Attachment D
Comments Received

Brightline West Cajon Pass High-Speed Rail Project Environmental Assessment

Brightline West Cajon Pass Environmental Assessment -Final

The Metropolitan Water District of Southern California (Metropolitan) reviewed the Environmental Assessment (EA) for the Brightline West Cajon Pass High Speed Rail Project (Project). The public comment period for the EA begun on October 28, 2022 and ends November 28, 2022.

FIGURE 1: EXISTING AND PROPOSED HIGHWAY AND TRACK SECTIONS

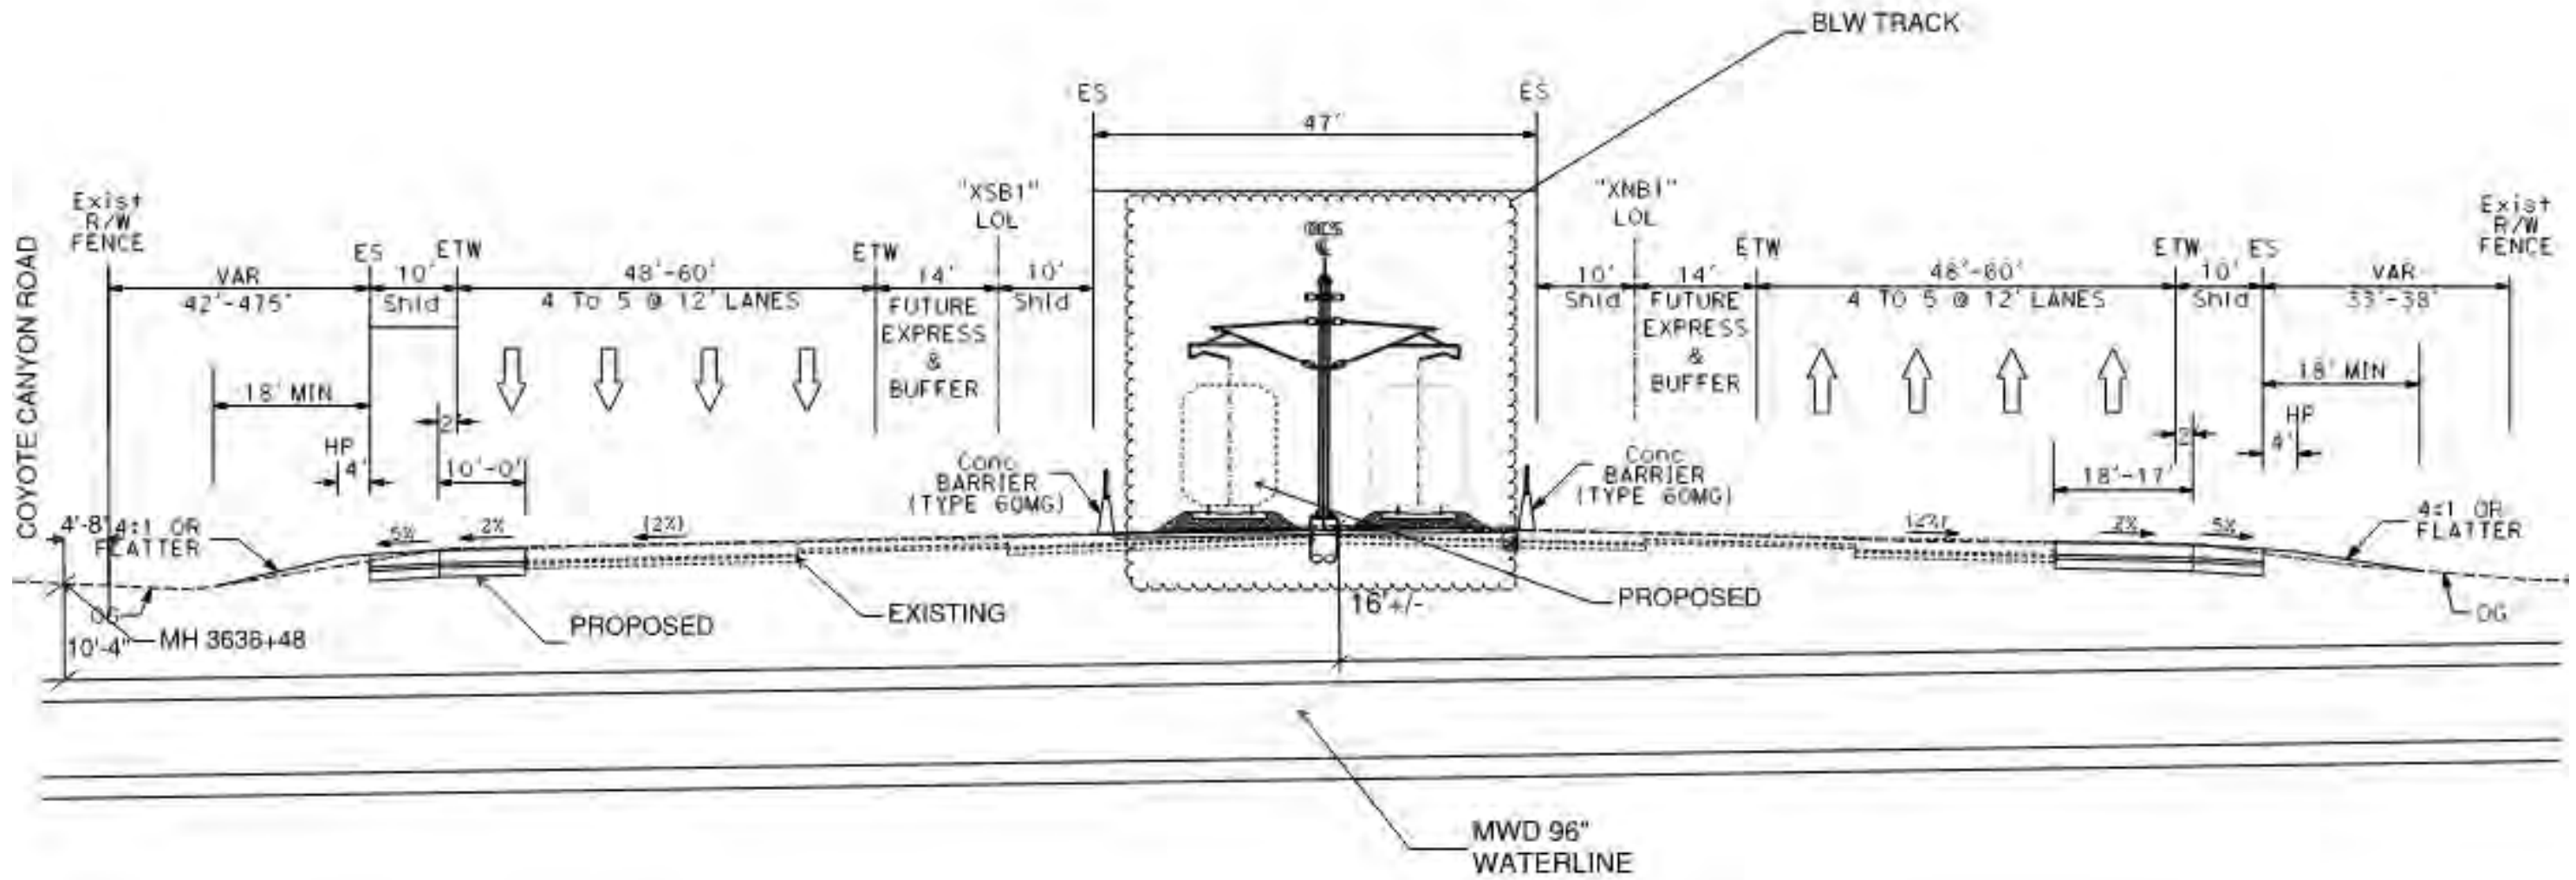
1. The proposed single-track high-speed rail crossing over our Rialto Pipeline and fee-property right-of-way as described in the memorandum, is conceptually acceptable to Metropolitan. However, the developer must submit plans and specifications for Metropolitan's review and written approval at least 60 days prior to beginning construction. Additional supporting calculations, including a 3D analysis, will be required to show that the proposed rail crossing will not adversely affect Metropolitan's Rialto Pipeline.

2. Metropolitan has concerns that the specified loading standard (Cooper E-70) does not fully encompass the high-speed rail's impact to our facilities. Please provide the following:

Figure 1 Showing Alignments of Rialto Pipeline/Proposed Railroad Track and Seismograph Locations

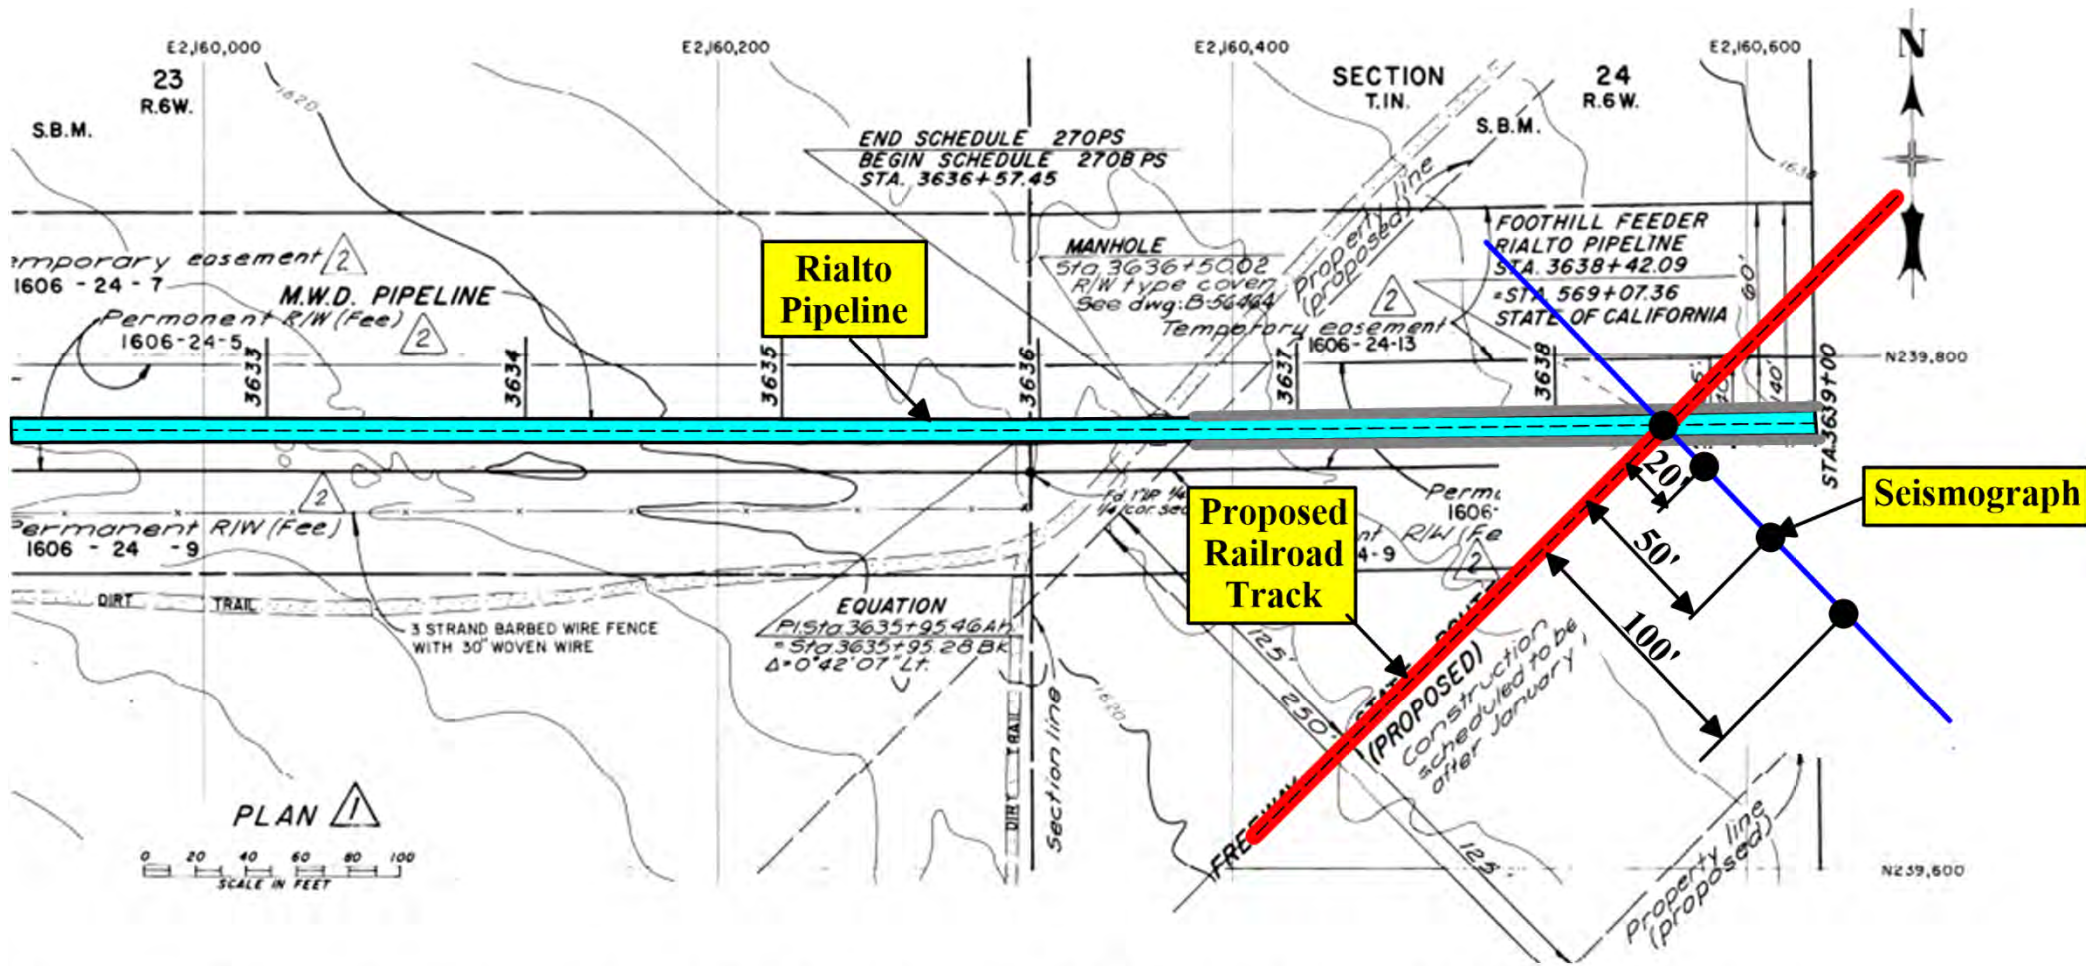
Figure 1 shows the plan view of the track of the proposed High-Speed Train (HSP) and the alignment of the existing Rialto pipeline. Based on the figure, the HST is obliquely overcrossing the pipeline while inducing not only cyclic vertical and horizontal displacements but also twisting the affected reach of the pipeline alignment clockwise and counterclockwise in the horizontal plane. The cyclic deformations of the pipeline could be evaluated if a few seismographs were installed on the ground surface for example at the track, 20, 50, and 100 feet away from the track, as shown schematically in Figure 1, and recorded the ground motions while the HST crossing the seismographs. The measured ground acceleration/velocity/displacement time histories could be used to empirically estimate the pipeline deformations due to the HST overcrossing.

1. Available experimental studies/case histories providing the three components (two horizontal and one vertical) of the ground accelerations/velocity/displacement time histories at and adjacent to the HST track somewhere (e.g., California, Europe, Japan, etc.) having the same foundation conditions and using the same Siemens NOVO train with a maximum axle load of 38 kips with speed in the range of 125 to 155 miles per hour. The alignment of the array of seismographs, as presented in Figure 1, should be normal to the track in order to show the lateral attenuation of the Rayleigh waves with distance from the HST track. Note that the two horizontal components of each seismographs should be normal and parallel to the track. The measured ground acceleration/velocity/displacement time histories can be used to estimate the pipeline cyclic deformations and twisting due to the HST overcrossing.
